Land at Gosford

Technical Note 11: Response to Oxfordshire County Council (OCC)

22nd June 2023

| Appendix E - Traffic Flow Spreadsheet

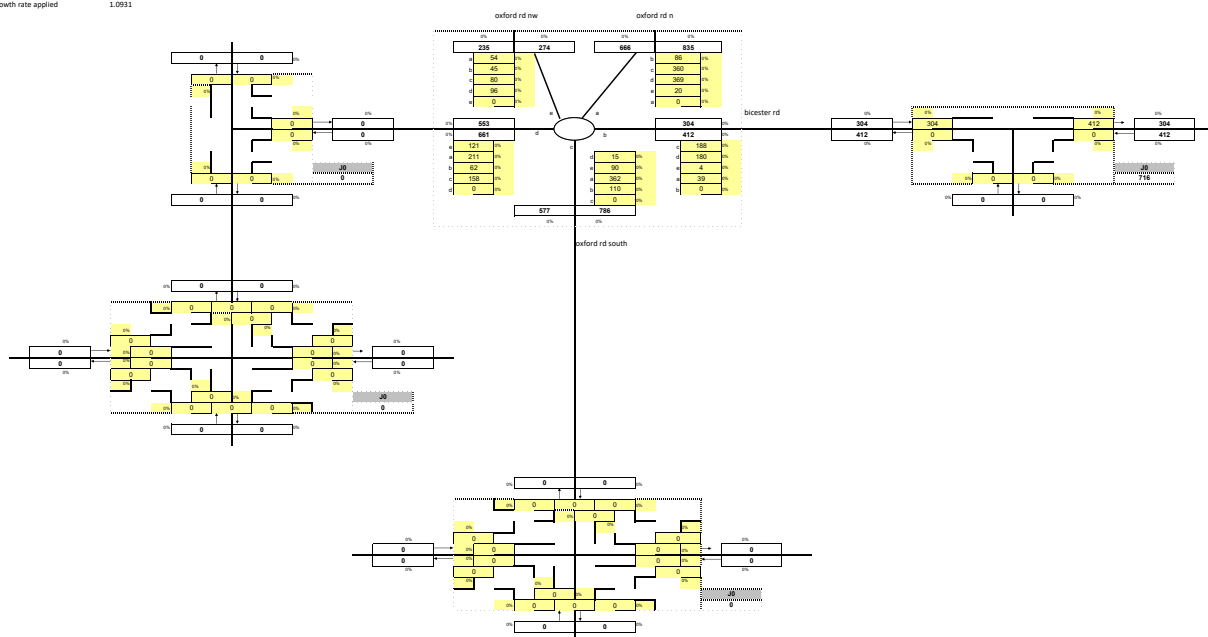
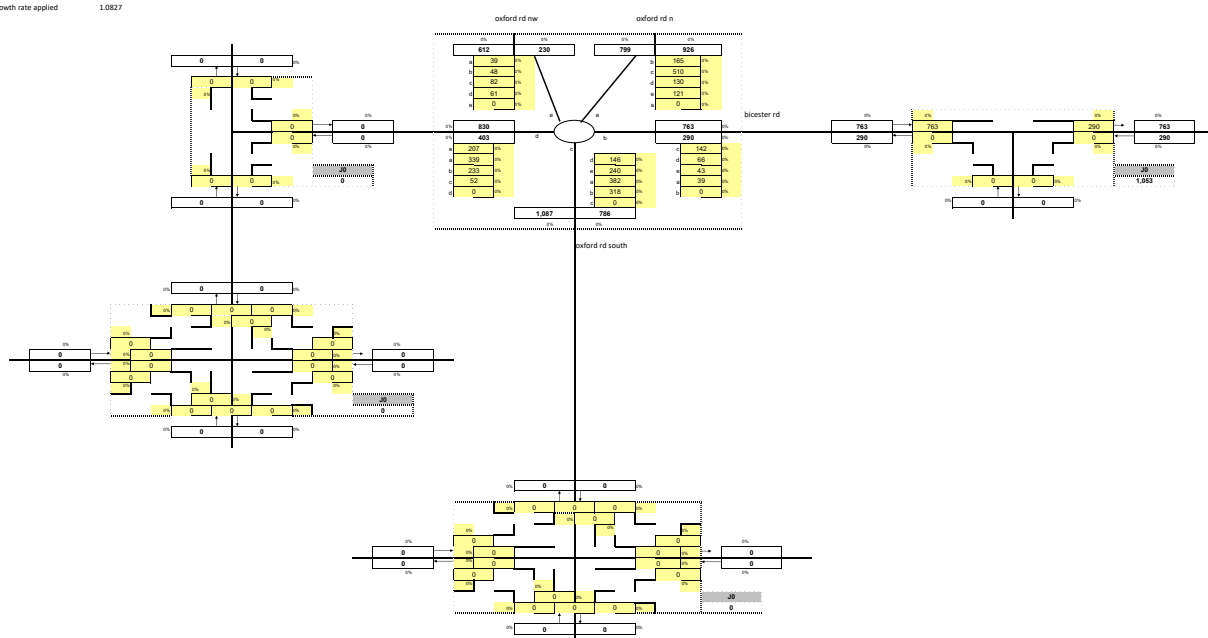
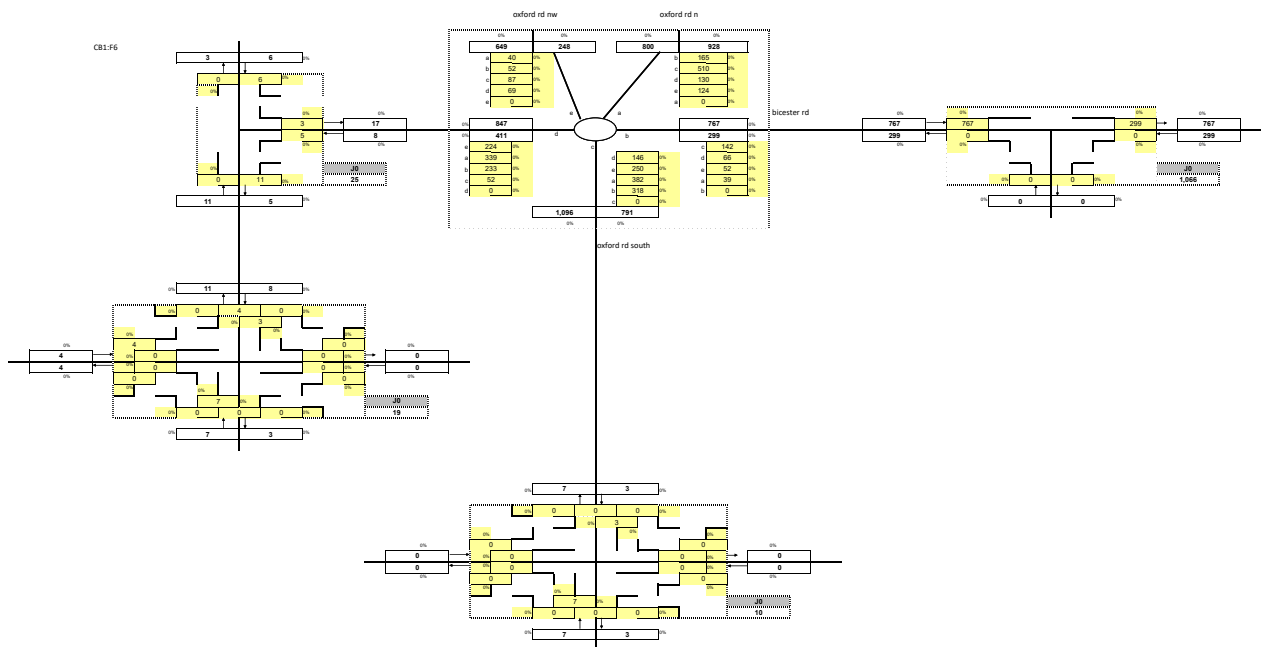
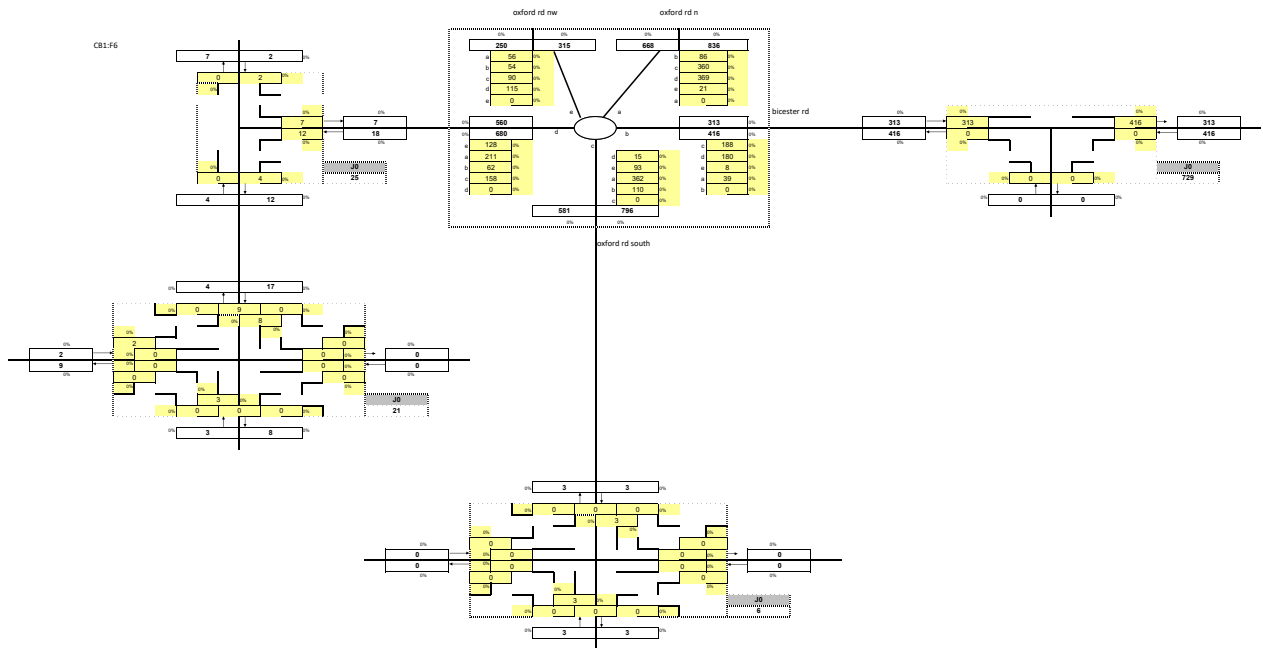
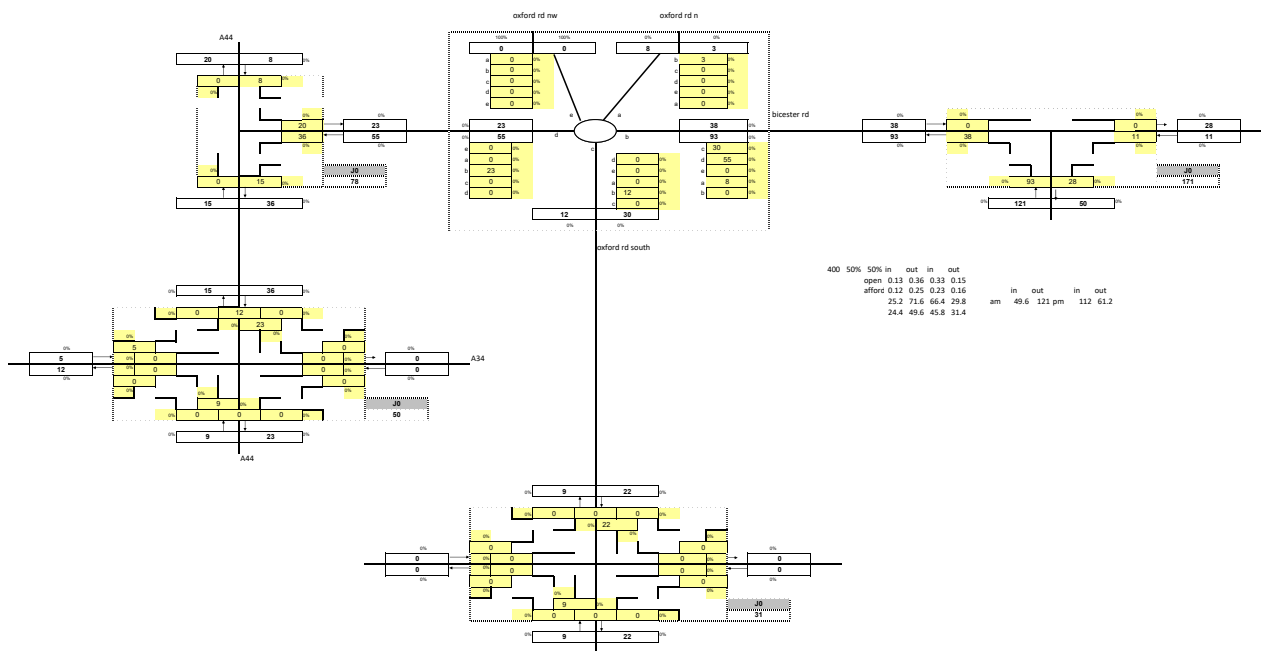
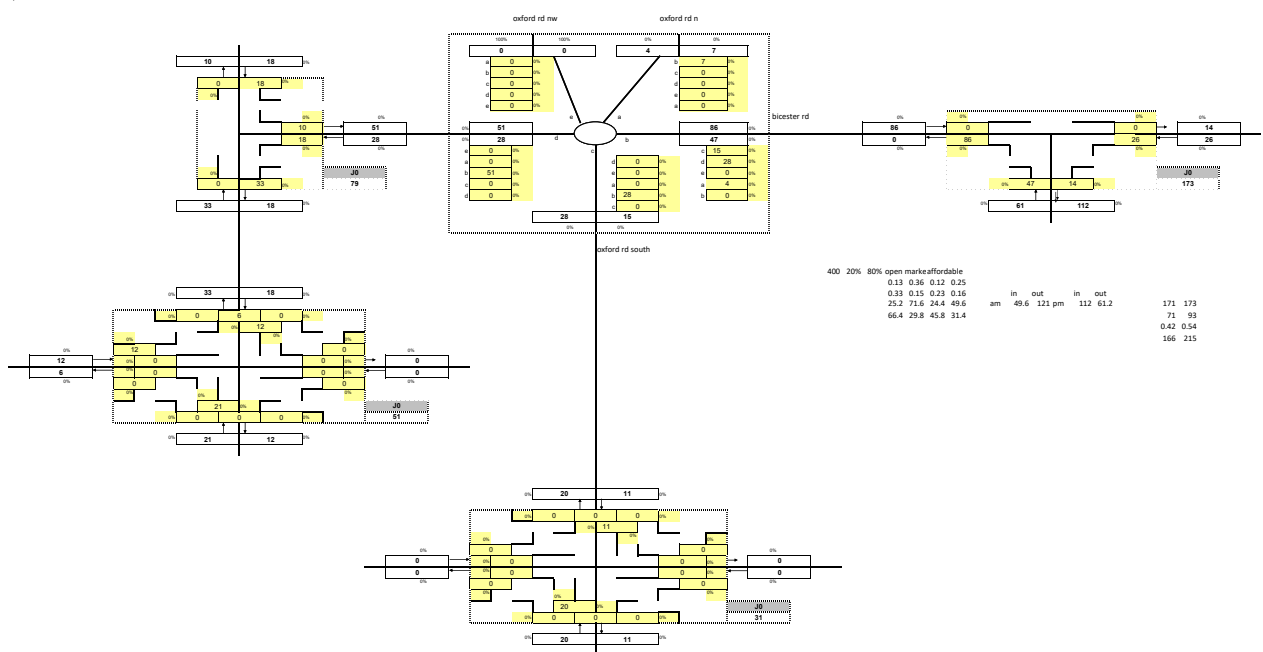
OCC Comment: The resultant traffic flow diagrams have been appended to the TA, interrogation of which is seemingly impossible to interpret. First, the diagrams need to show base year flows before introducing development flows, but instead the application has presented all movements under the future year scenario. The flow diagram is hence incoherent and needs to be simplified further. Turning movements cannot be interpreted, taking an example of the site access junction the distribution of vehicles plus development in 2031 AM peak. I however fail to interpret where 38 is taken from the 93 movements on the left turn from the site? The 28 movements shown to be accessing the site need to be explained.

1. Besides the site access junction and the Kidlington roundabout, other junctions mapped on the flow diagram are simply a guess work.
2. Arms of junctions need to be named

3. It would be helpful for base year flows, committed development flows and future year flows to be separated out
4. What is the significance of the percentages are shown, what do they stand for?

3.25 The traffic flow diagrams requested are contained in **Appendix E**.

Figure 1-1: Accident Study Area

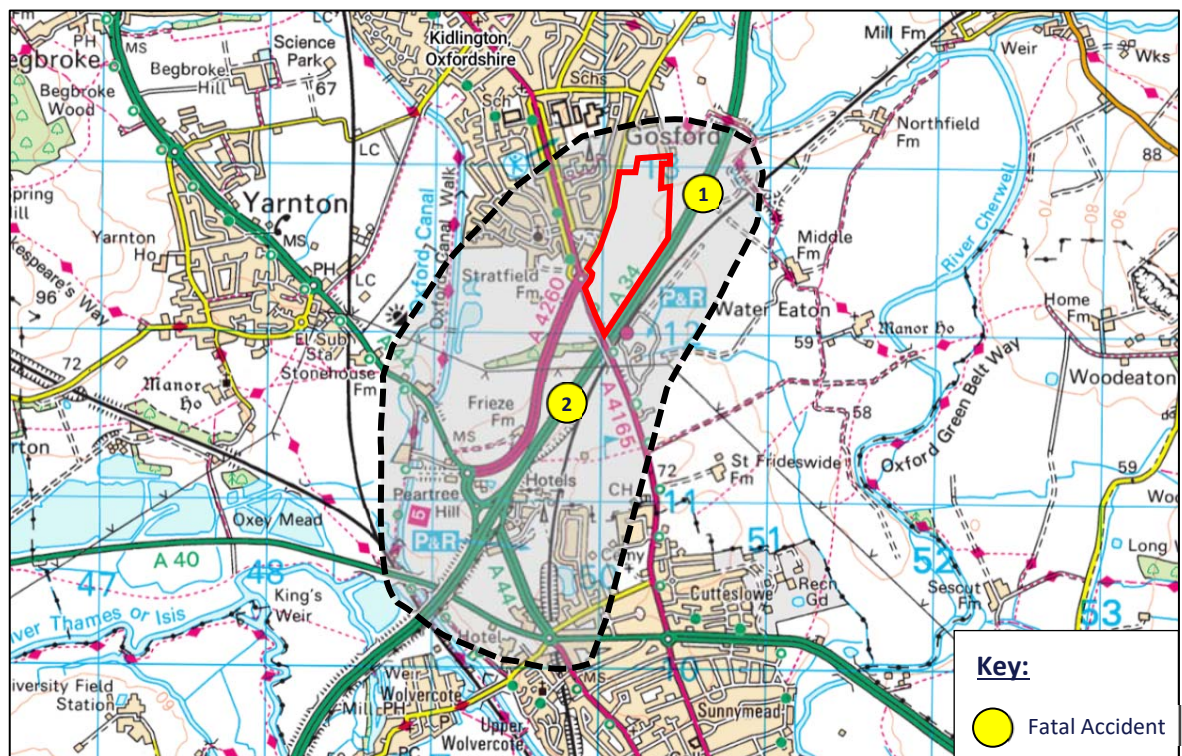
OCC Comment: 5.13 to 5.15 of the TA attempts to analyse the recent personal injury accident history on the highway network in the vicinity of the site. Analysis of the personal injury accident records on the public highway in the vicinity of the site was obtained from OCC. This range of data is a 5-year period from 2015 to 2019. This period, however, is not the most recent and to undertake a satisfactory assessment from which to identify any significant highway safety issues, the application should analyse the most recent 5-year period. Reason for objection.

OCC Comment: OCC Comment: Para 3.42 reports that by way of updating the collision data beyond 2019, Crashmap was used to obtain the 2020 record. The updated record is however not presented anywhere in this TA for us to corroborate this information. The collision map included in Appendix C of the TA is the data obtained by OCC but not Crashmap.

OCC Comment: The personal injury collision study area appears to focus more on vehicular routes and less on routes that pedestrians/cyclists would be attracted to. To put this into context, Fig 3-2: PIC Study Area of the TA shows the study area covering Frieze Way and the A44 but only stops a few hundred metres along the A4260 Oxford Road north of the Kidlington roundabout. Kidlington is the nearest centre within walking distance from the site with a number of local amenities hence I would have expected to see the study area covering more of the A4260 stretch into Kidlington in anticipation of more walking trips.

- 3.36** The accident history presented in the TA was based on the latest data from OCC that was available at the time of document production. The latest accident history is reviewed and reported in **Appendix F**.

- 3.37** The latest accident history has been presented in **Appendix F**.

- 3.38** The latest accident history within the suggested study area has been considered, concluding that the Application Site will not have a material impact on personal injury collisions.
